APPLICATION NO.	FILING DATE	FIRST NAMED INVENTOR	ATTORNEY DOCKET NO.	CONFIRMATION NO.
10/791,997	03/02/2004	Daniel J. Coster	APL1P290/P3186	4300

Office Action Summary	Application No. 10/791,997	Applicant(s) COSTER ET AL. 	
	Examiner Zachary M. Pape	Art Unit 2835

DETAILED ACTION

Fig 1

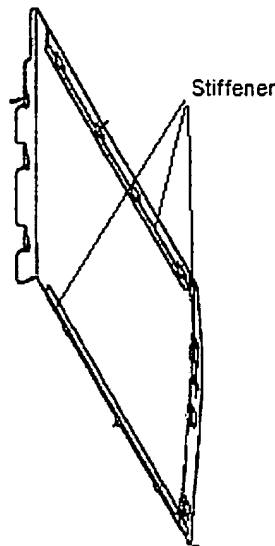
With respect to claim 38, as best can be understood by the examiner, Chen et al. further teaches a stiffener (See present office action Fig 1 below) that is attached to an inner surface of the planar access door, the stiffener being configured for insertion into a recess within the access opening when the access door covers the access opening.
